Index 102-661 Bicycle Lane Closure

COMMENTARY

COMMENTS AND RESPONSES

102-661 Sheet 1 of 2:

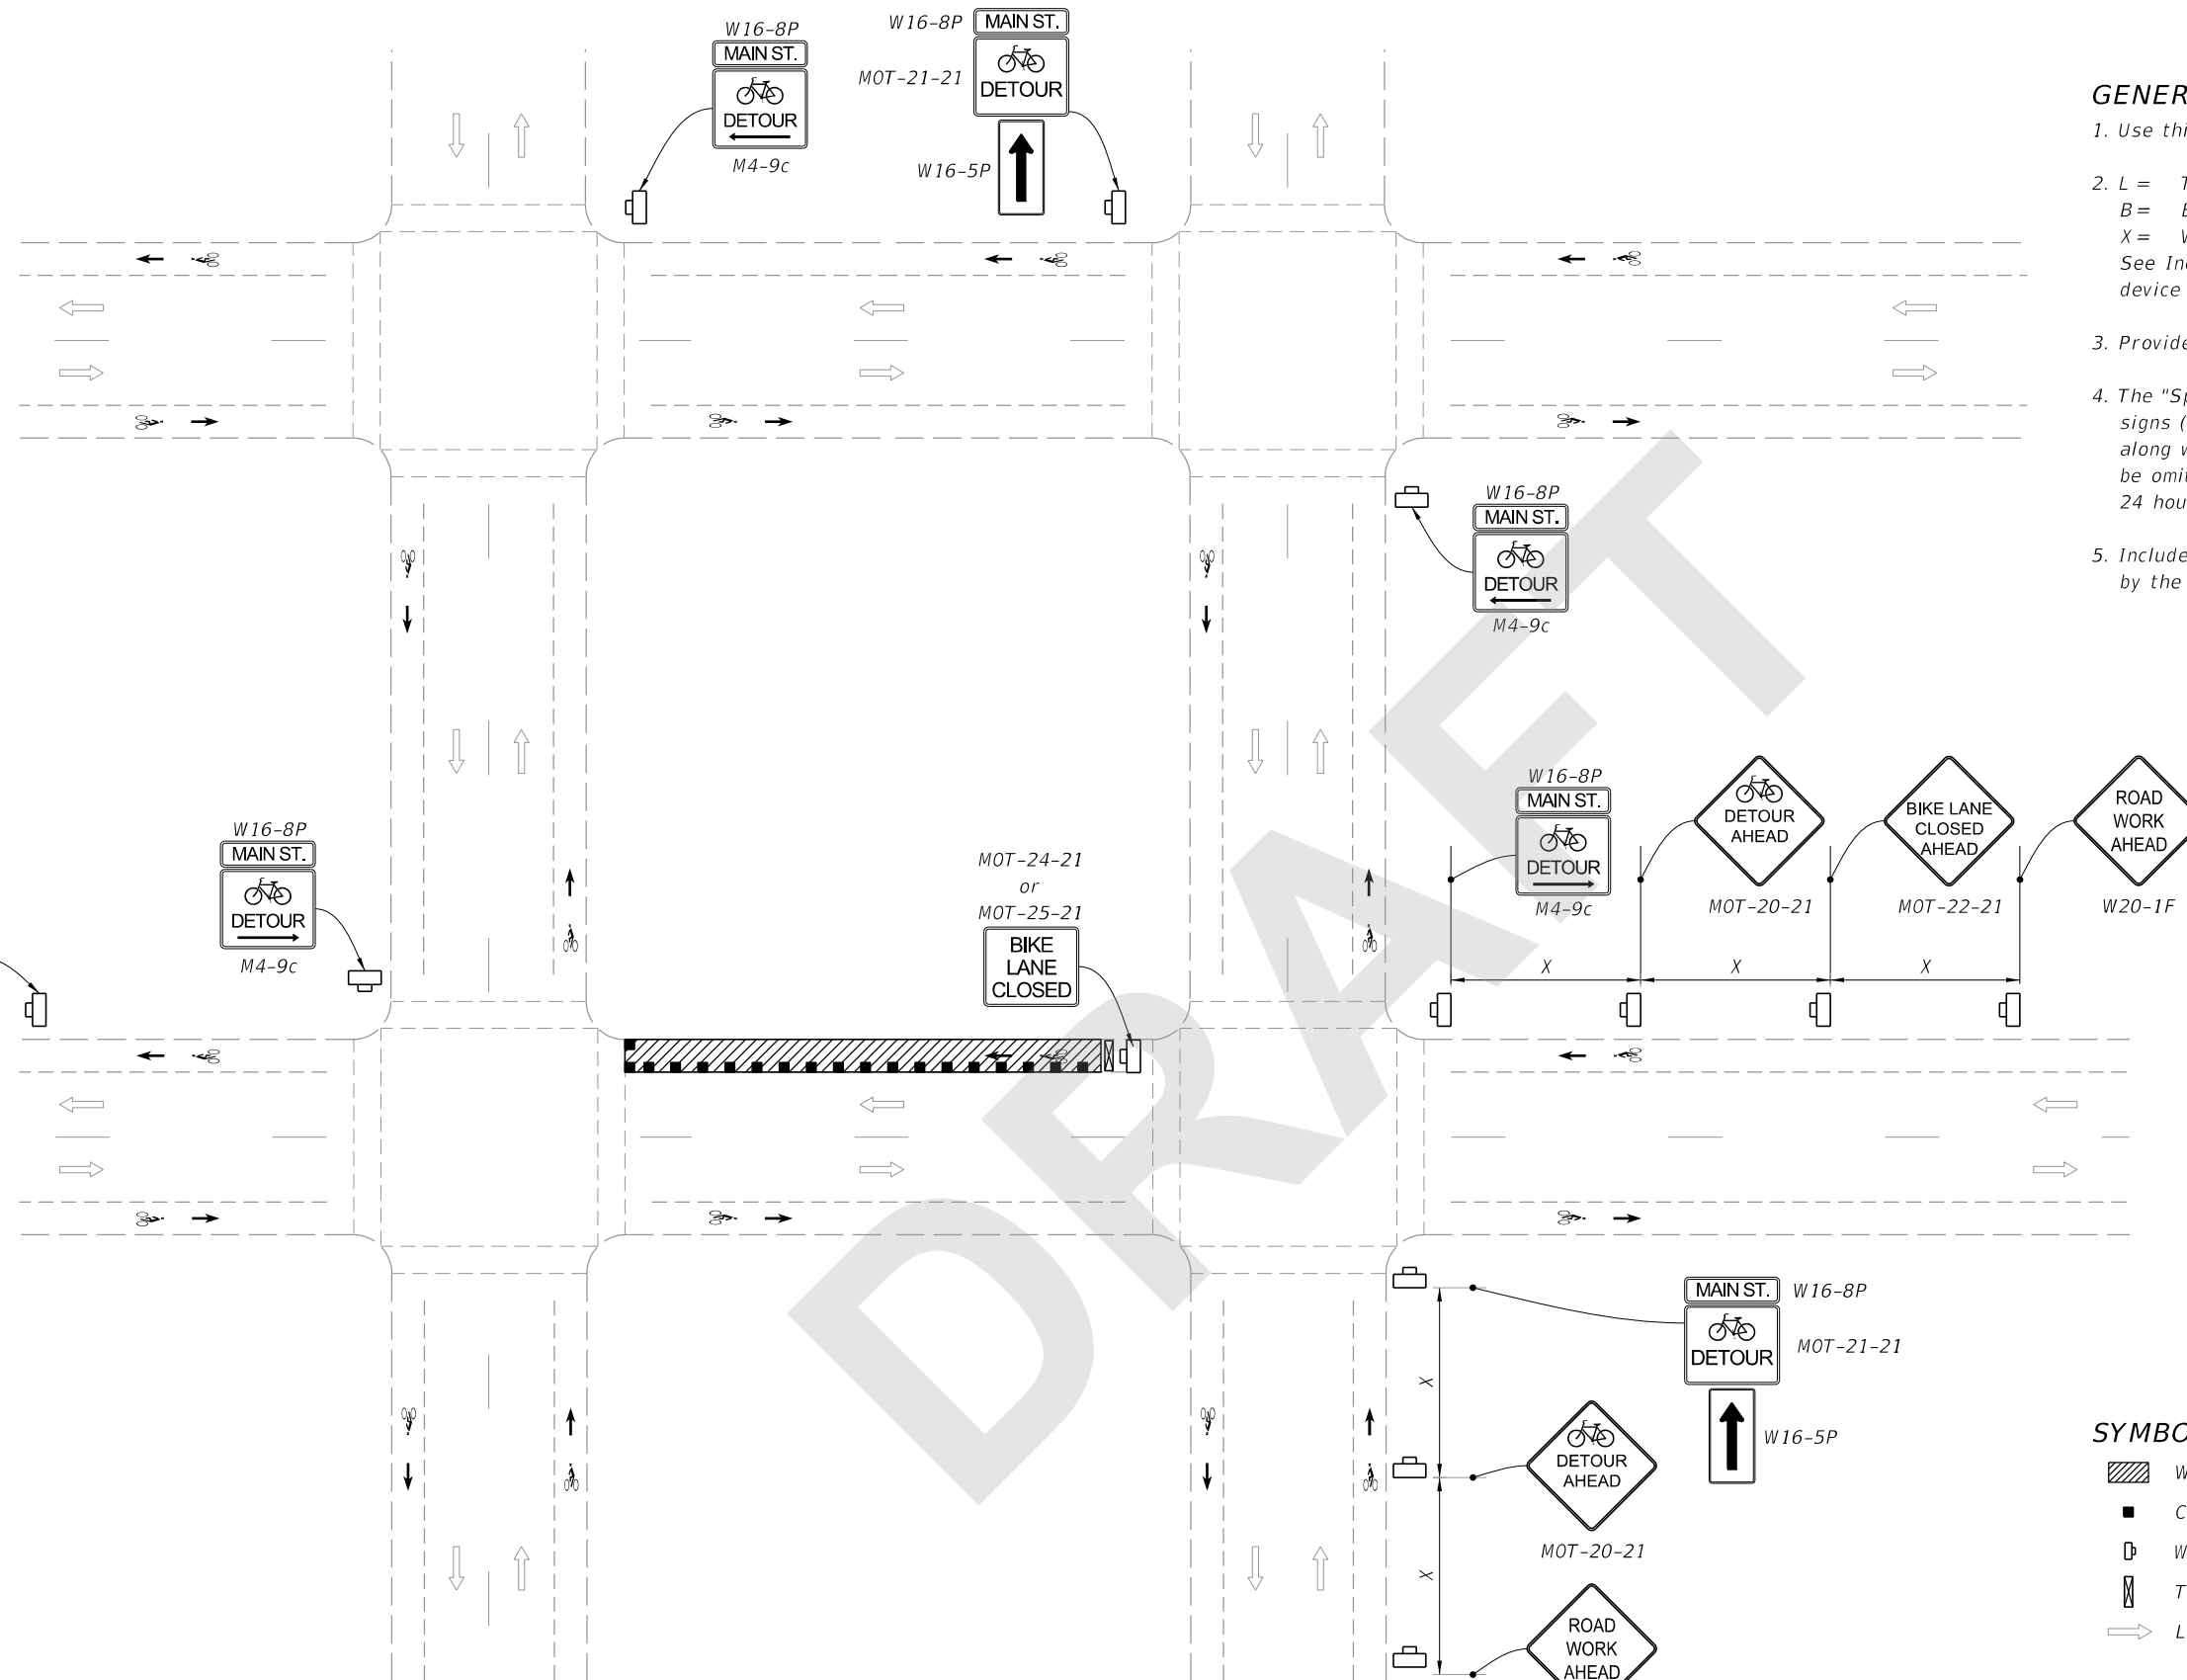
1. Sheet 1: may only be feasible if there are alternative bicycle lanes / routes in the proximity of the affected construction area. If field conditions do not mirror the depiction shown on 102-661 Sheet 1 of 2, what is the alternative?

- North and West detour sign M4-9c move up the street (far side of the street)
- Why you need a detour, the mainline can be used as a bicycle lane.

Sheet 1: Consider tying the taper length $L/3$ to the width of the diversion. $L/3$ looks appropriate for a 4-foot shift but may not be appropriate for a 12-foot shift. This is especially obvious in the Temporary Bicycle Diversion graphic. If L does not map well to the same L for motorized vehicles, consider providing specific guidance for L , B , X (and the appropriate channelizing device spacing within each) for bicycle traffic in this section.

Alternative to detour. Is there any option for SHARROW when posted speeds are conducive, in lieu of full detour?

RESPONSE: Like all Typical Applications in the TTC Standard Plans, this application is rudimentary and may have limited applications as specifically detailed. The intent was to provide basic signing requirements for bicycle detour, if needed.
No Change

RESPONSE: The intent is for the bicyclist to turn at the intersection. If the signs are on the far side of the intersection it may not give a cyclist appropriate advance warning to make the proper turning movement. Signs are located in accordance the NCUTCD Approved Typical Applications.

RESPONSE: The $L/3$ is used for shoulder taper per the MUTCD. The geometry of the diversion would be site specific. Currently, the intent is of the L , B , and X values of Index 102-600 to be used.

RESPONSE: The current applications provided in this Index follow the guidance included in **FDM 240** for Bicycle and Pedestrian Accommodations through work zones, which does not acknowledge the suggested option. However, the option is included in the NCUTCD approved Typical Applications and may be appropriate for some locations.

LAST REVISION 11/01/20	REVISION	DESCRIPTION:		FY 2021-22 STANDARD PLANS	BICYCLE LANE CLOSURES	INDEX 102-661	SHEET 2 of 2
---------------------------	----------	--------------	--	------------------------------	-----------------------	------------------	-----------------

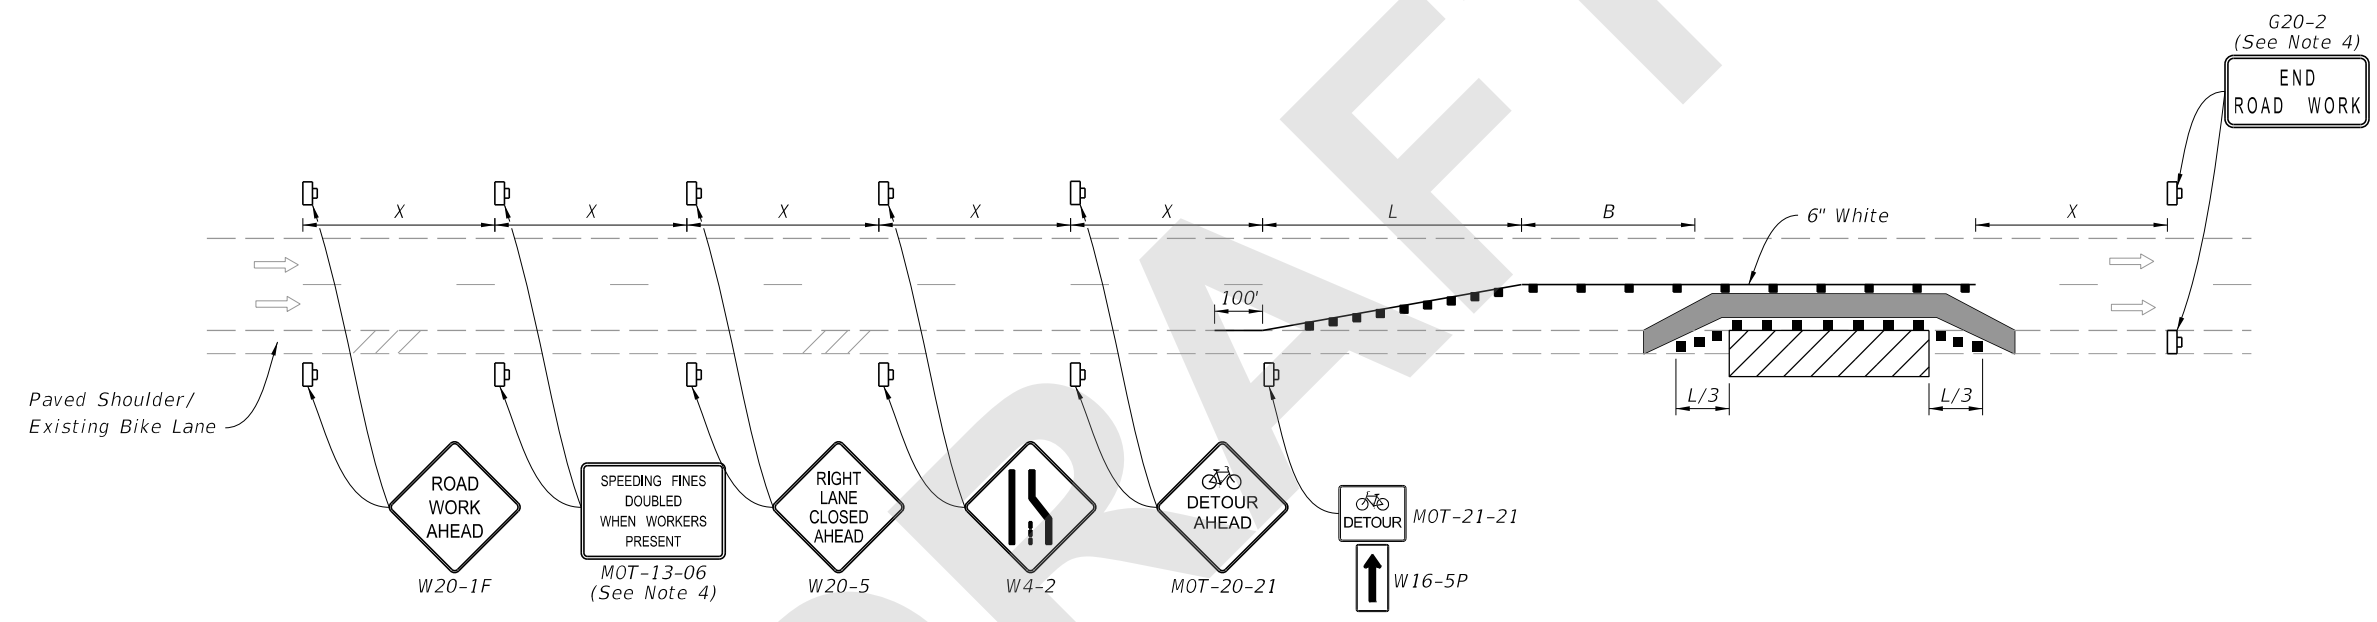
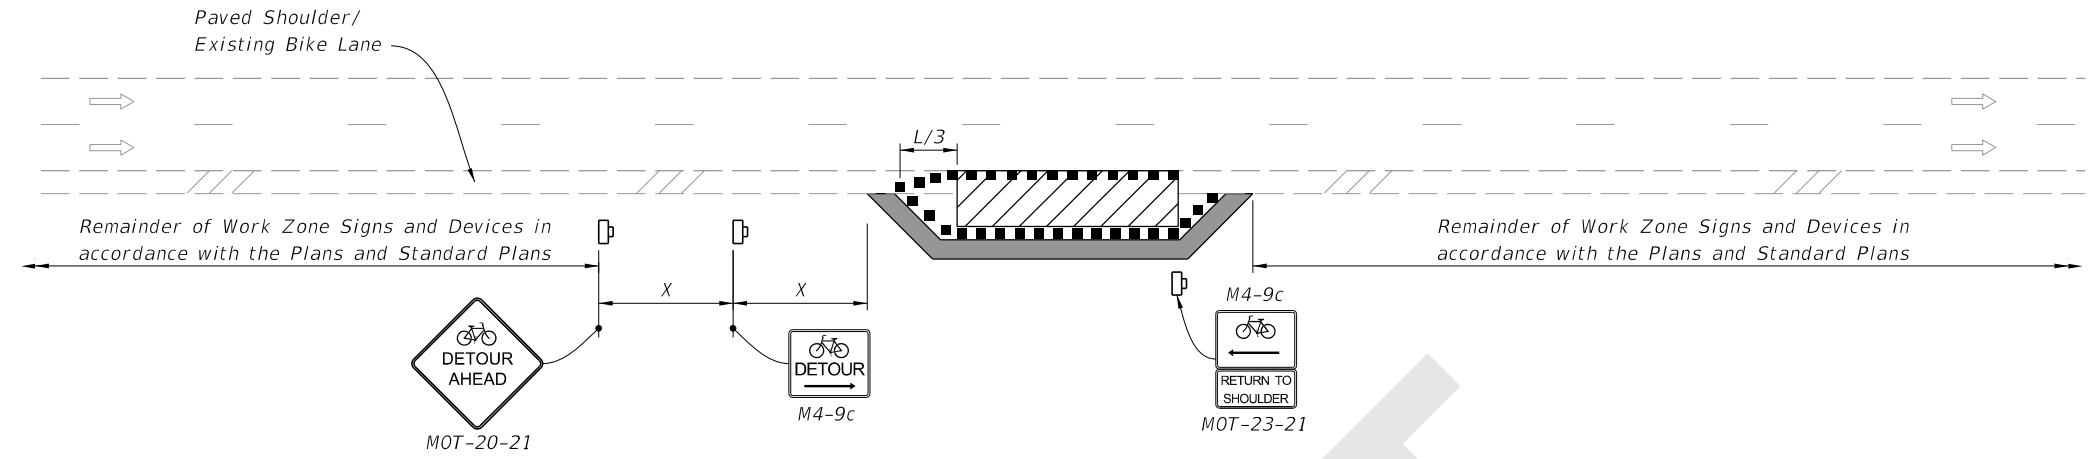
2. Are we to follow sheet 2 of 2, and remove a lane of vehicle travel? Following Sheet 2 of 2 may lead to significant issues if a full-time lane closure is implemented on a major roadway. Index 102-661 may need to be re-visited

3. Sheet 2:
 - LCD (longitudinal channelizing devices) may be installed for the protection of the bicyclists in the Detour / diversion portion.
 - Material (temporary asphalt – compacted) may be specified for the diversion in the legend/ symbol.

- Section 5 of NOTES – please check “included” – should this not be include??

My comment is on sheet 2, second graphic; I believe the SHOULDER CLOSED AHEAD Sign is redundant to the RIGHT LANE CLOSED AHEAD sign since the right lane closure would block vehicle access to the shoulder. However cyclists would benefit from the BICYCLE DETOUR AHEAD sign in advance of the taper so that they know they do not need to merge into the vehicle lanes (which the SHOULDER CLOSED AHEAD sign implies). Maybe it could coincide with the beginning of the 100' stripe.

RESPONSE: See **FDM 240** for guidance on Bicycle and Pedestrian Accommodations through work zones (i.e., the existence of this Index does not make it a requirement). The details included within Indexes 102-601 thru 102-680 are not criteria. They are Typical Applications which can be used were appropriate as a substitute for, or in combination with, TTC Plans.
No Change

RESPONSE: LCDs are not required for bicycle specific accommodations. If Pedestrians are to use the facility along with bicyclist (e.g., a hybrid Ped./Bike Diversion), LCD's may be needed. The materials requirements will be addressed in Specification 102 along with Pedestrian Detours. The note has been corrected (i.e., Include...)

RESPONSE: Agreed, the signs have been updated to better communicate the intended travel path for the bicyclist.
